# Broadcast Products Technical Bulletin 20-2007-092

SUBJECT: AUDIO CLICKING NOISE

MODEL: *HDC1500//UL***DESCRIPTION**

Figure 1

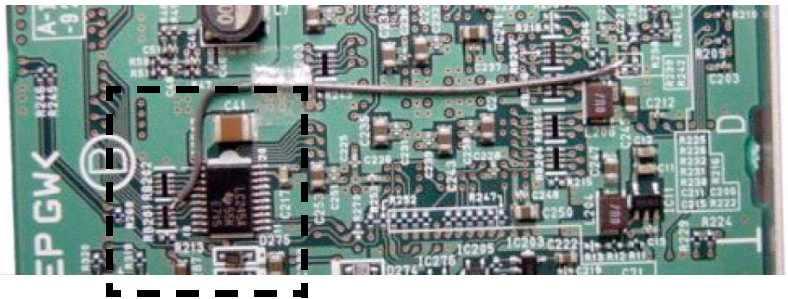
Audio clicking noise may occur in MIC audio output.

If the jumper on the DAP-33 board (suffix -12) is attached to RB202 instead of RB201, reattach the jumper to RB201. (See Figure 1.)

Confirm that noise does not occur in MIC audio output.
